Agilent 35670A Dynamic Signal Analyzer

**Supplement to Installation,
Service and Operator's Guide**

The purpose of this supplement is to describe changes to the display of the Agilent 35670A. These changes apply only to instruments with a serial number higher than MY42506200 made after December 2002.

Figure 16 Front panel parts

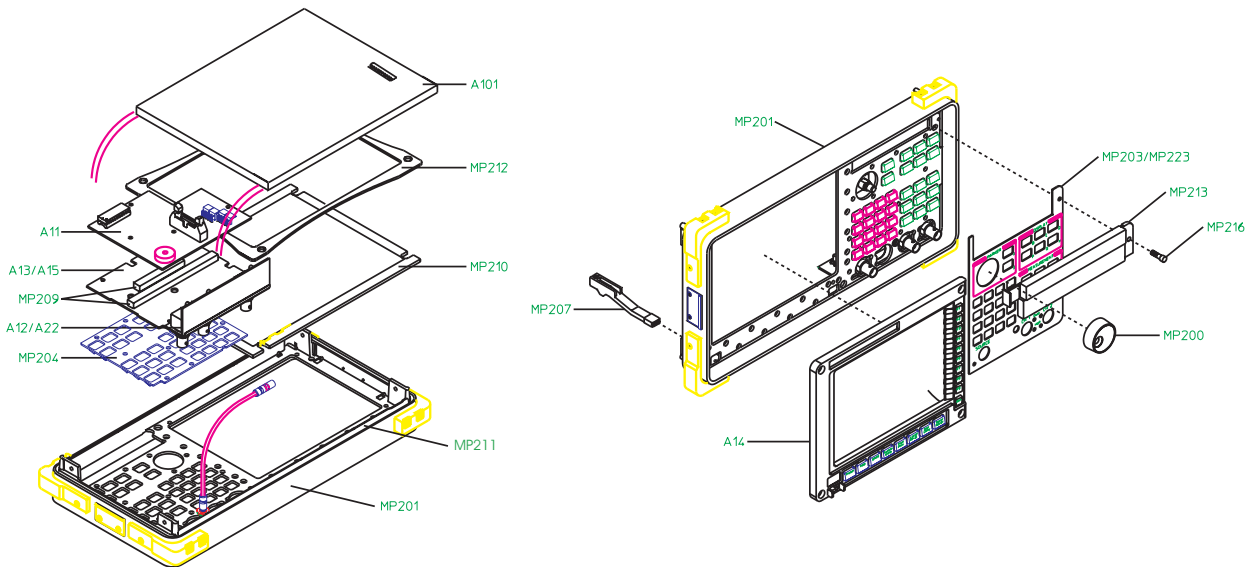
Three parts have been replaced and a new one added:

Figure 17 Two channel overall block diagram

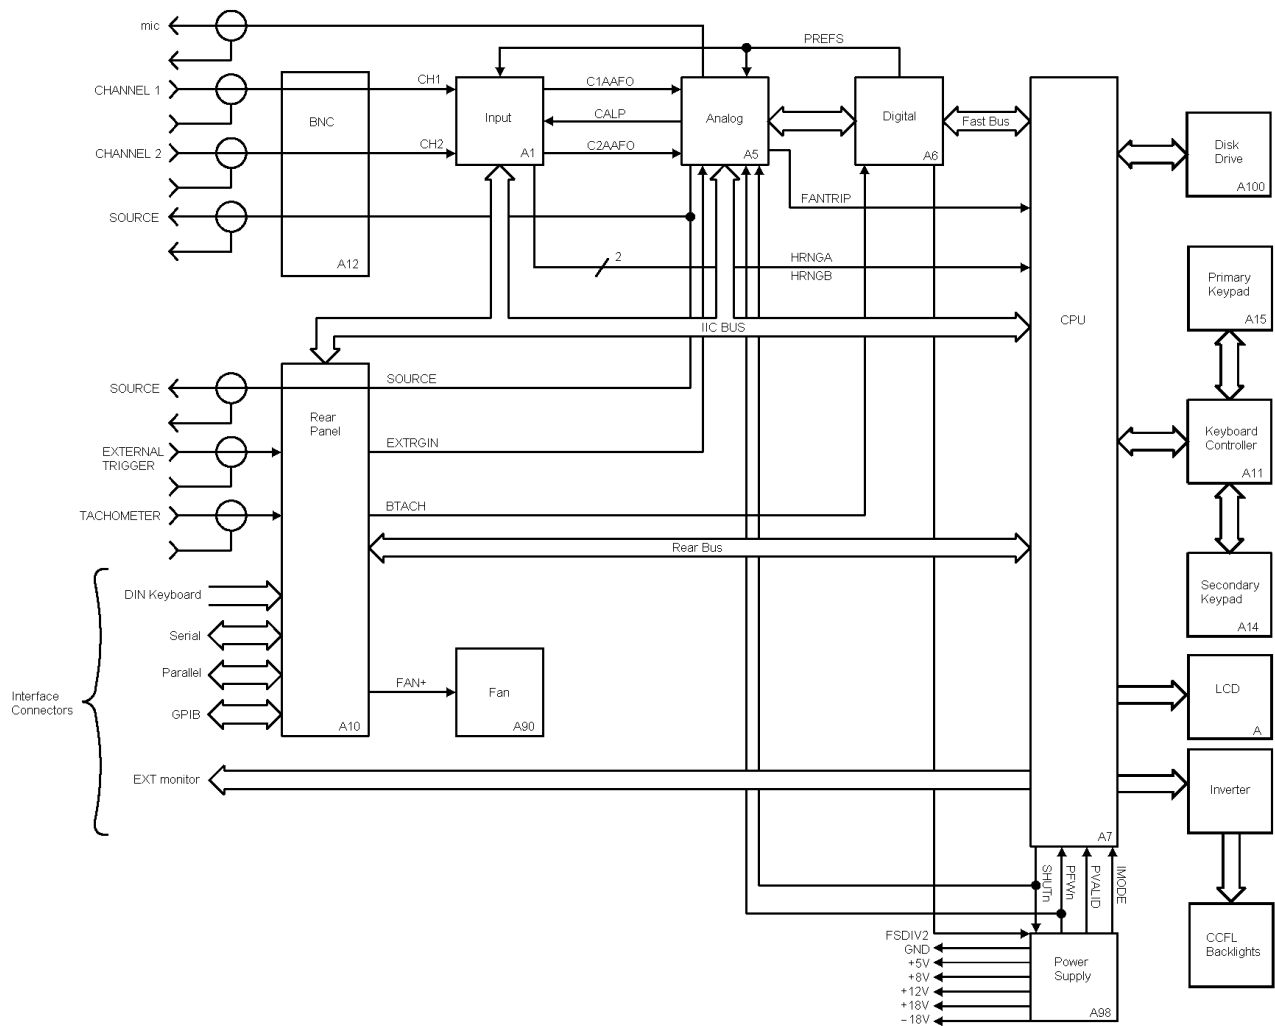
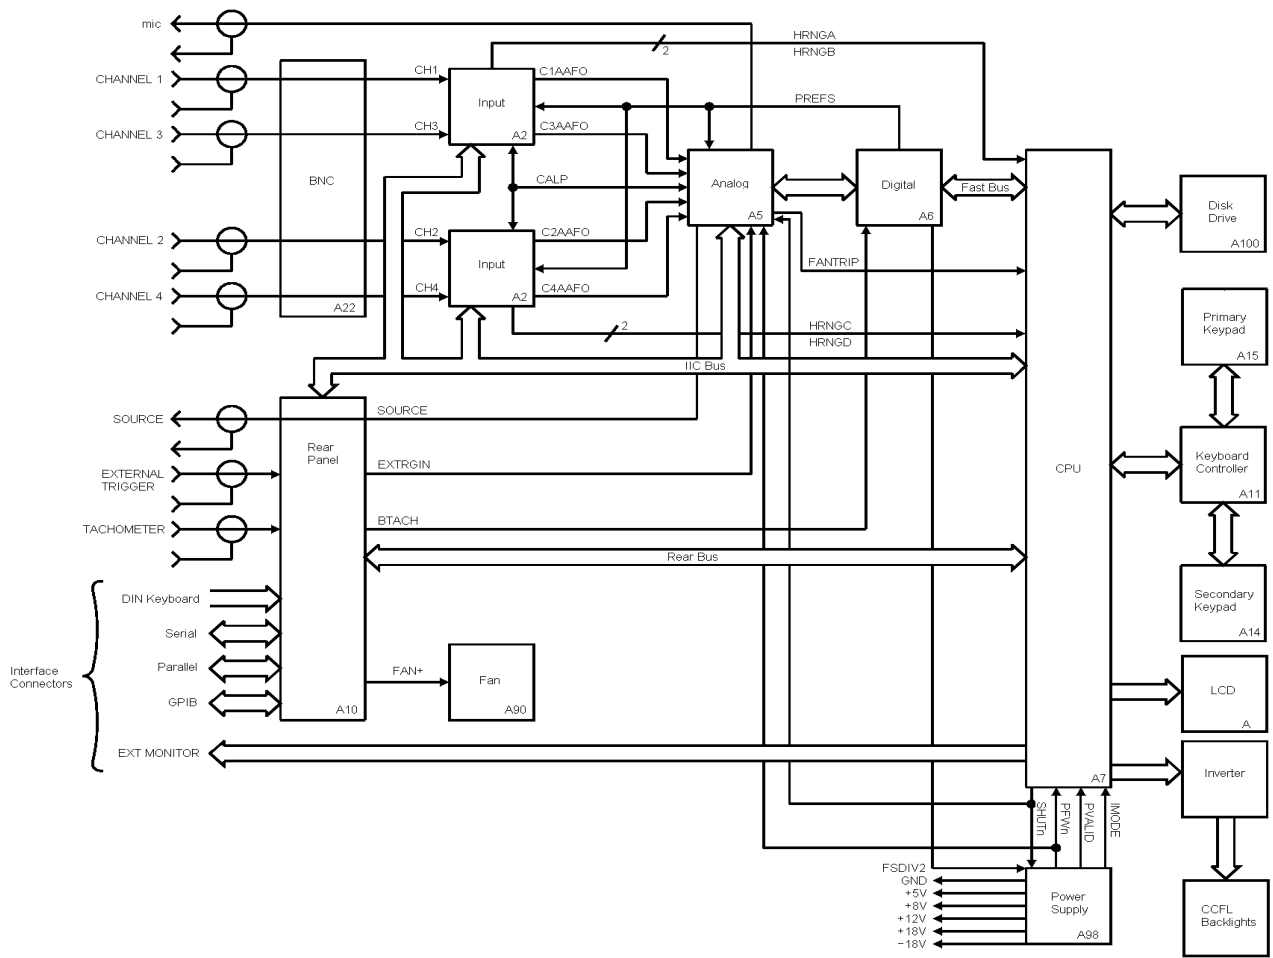
The Memory and NVRAM assemblies are now incorporated into the CPU assembly. The additional NVRAM option assembly is now standard and consolidated onto the CPU assembly.

The DC-DC Converter has been replaced with a Power Inverter which generates the display backlight voltage.

Figure 19 A17 CPU Block Diagram

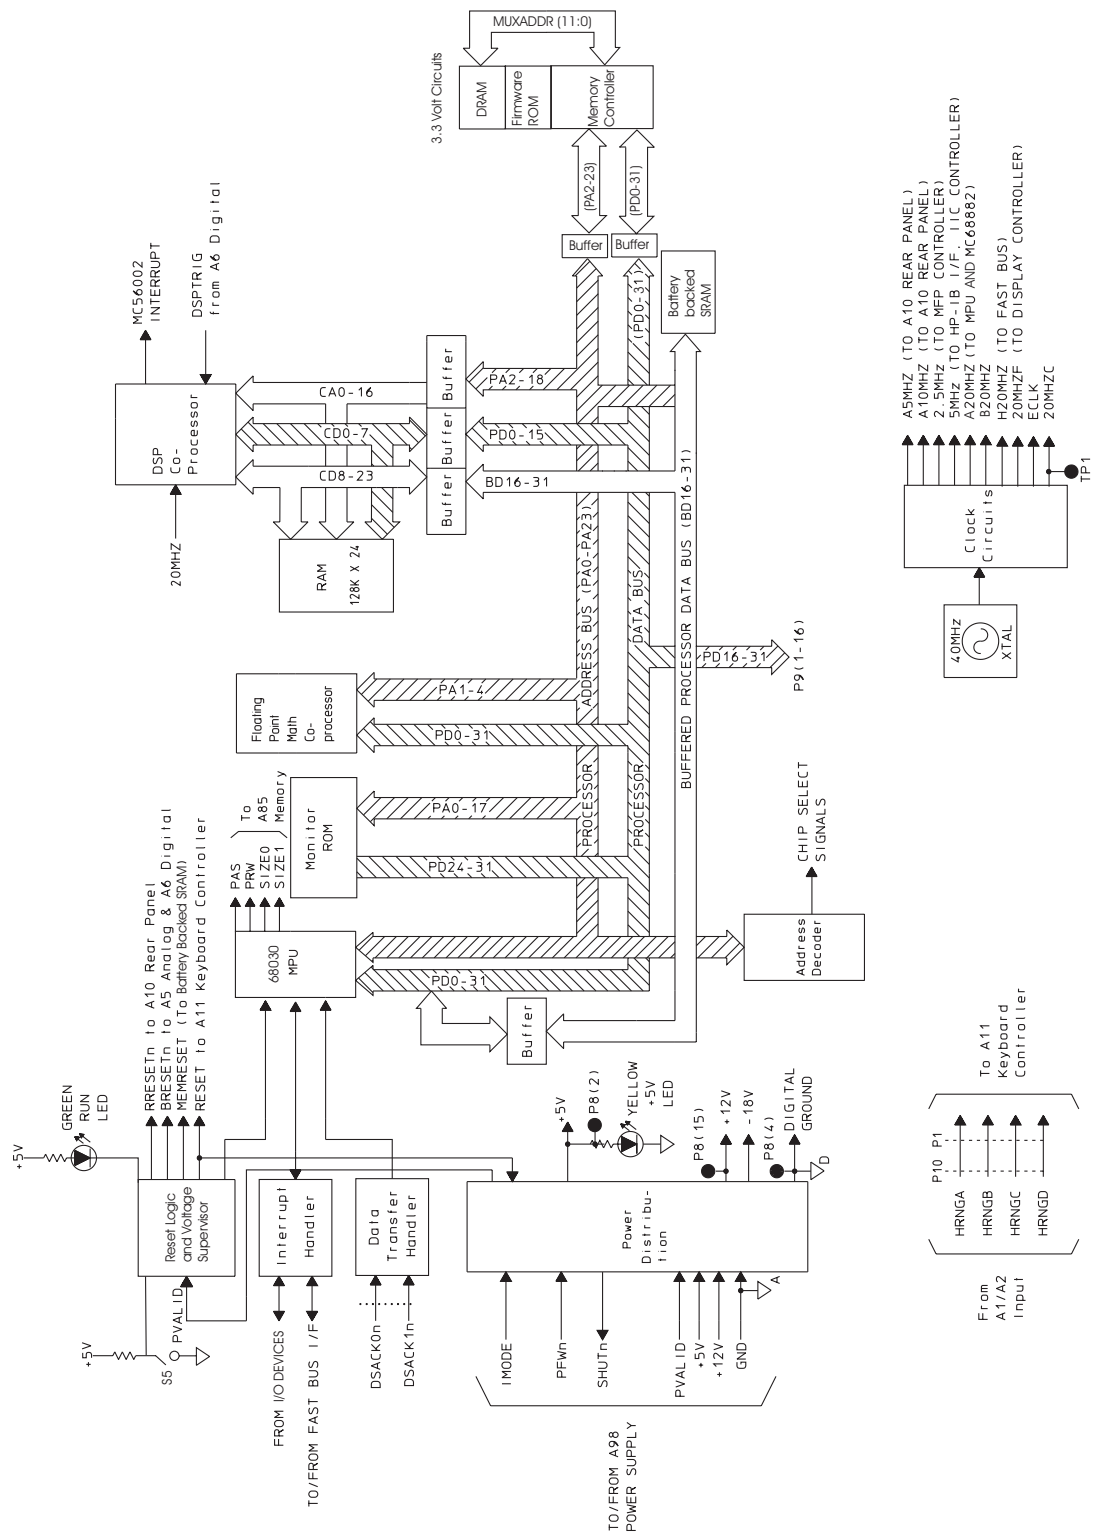
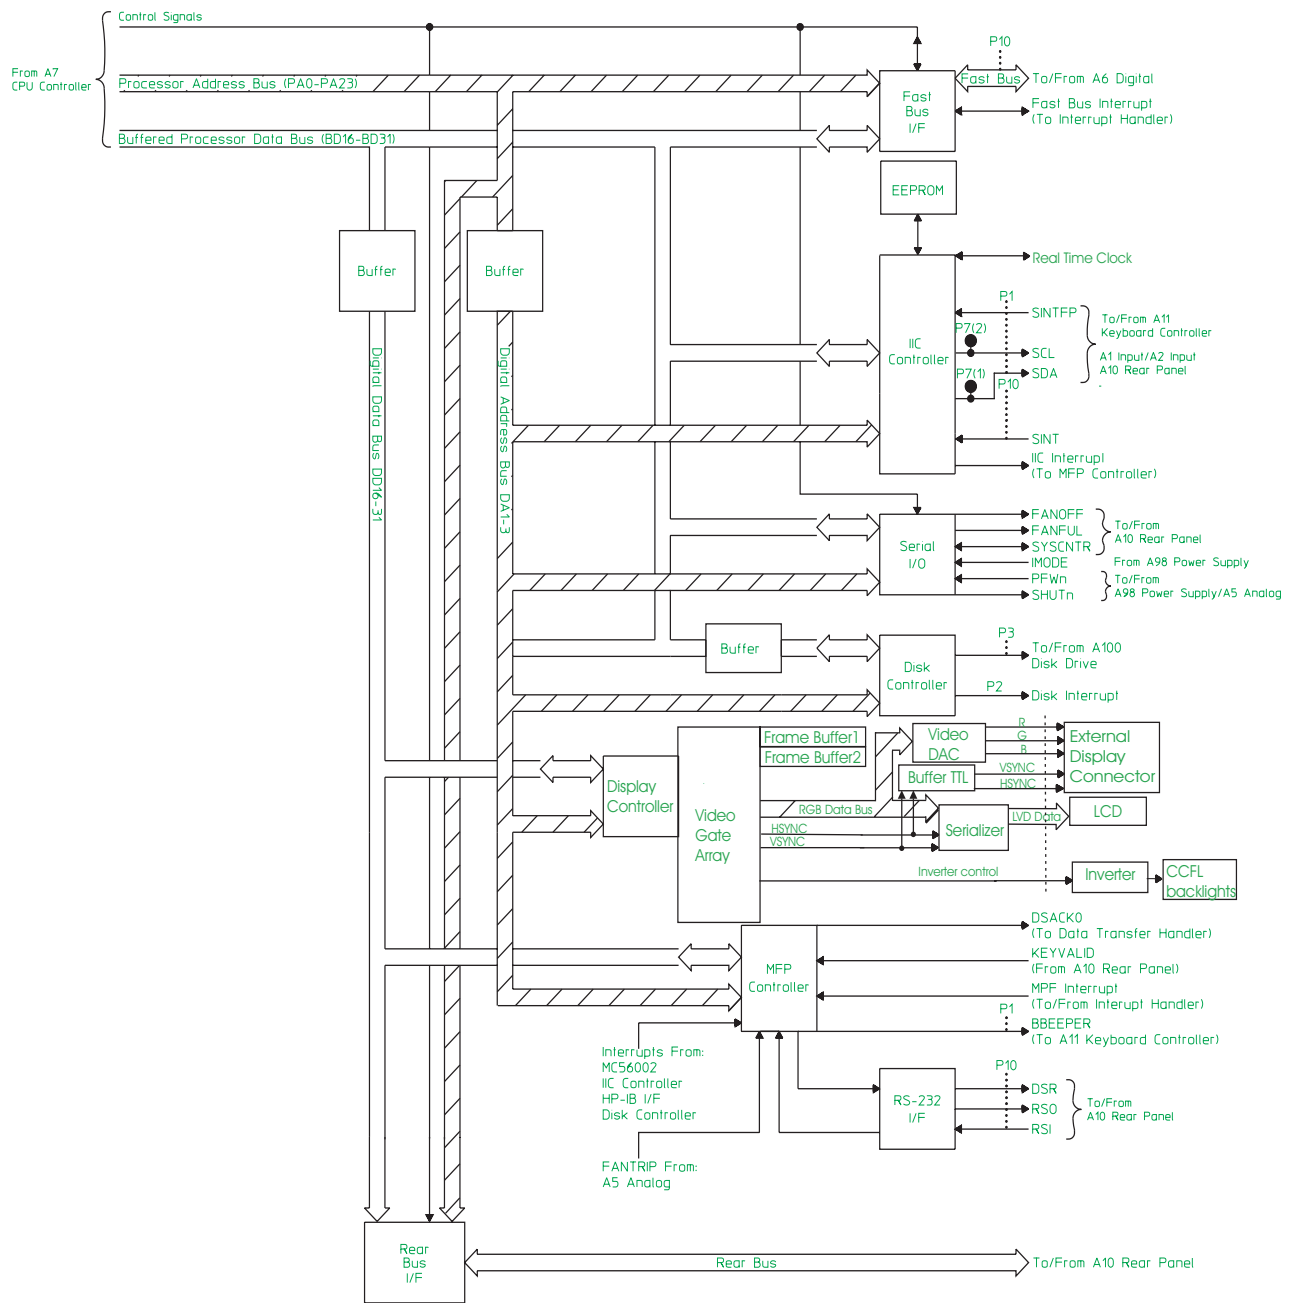
This is now the A17 CPU. Delete all references to A8 memory and A9 NVRAM as separate assemblies since they are now incorporated on the CPU board.

The A17 board now includes Non-Volatile Memory Storage operations among its tasks.

The Math Co-processor is 20 MHz rather than 40 MHz (error in previous documentation).

The 40 MHz oscillator is now a precision clock oscillator and is no longer adjustable.

Figure 21 Reset logic

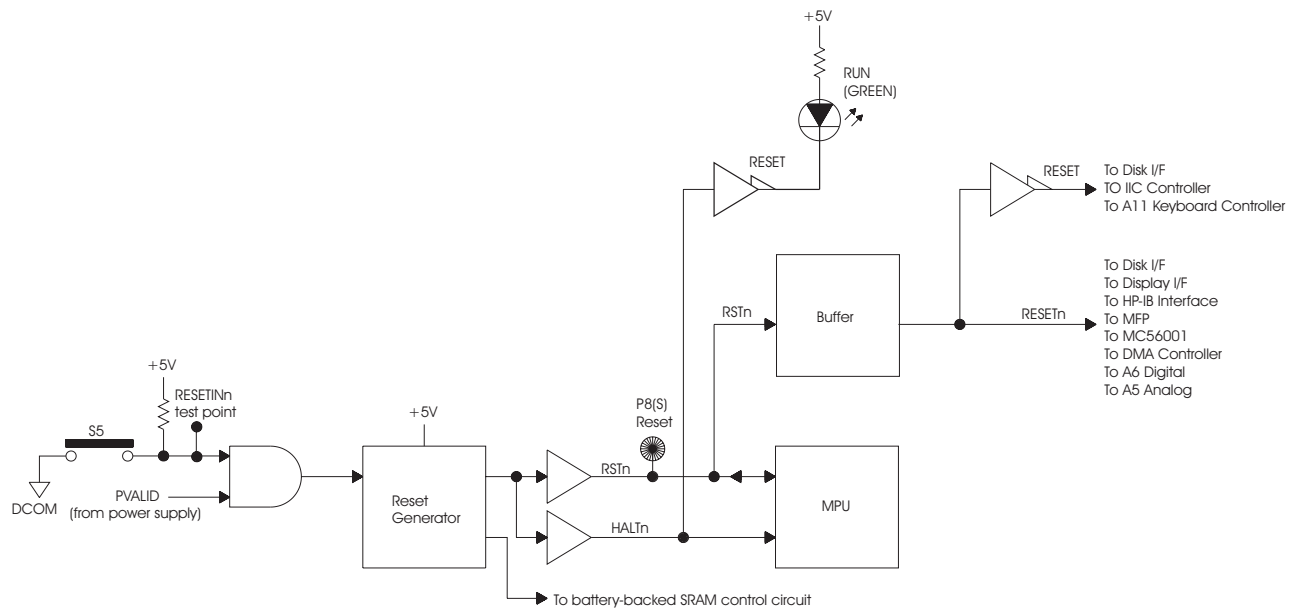
Reset logic all references to S2 are changed to S5 and there is a new block diagram.
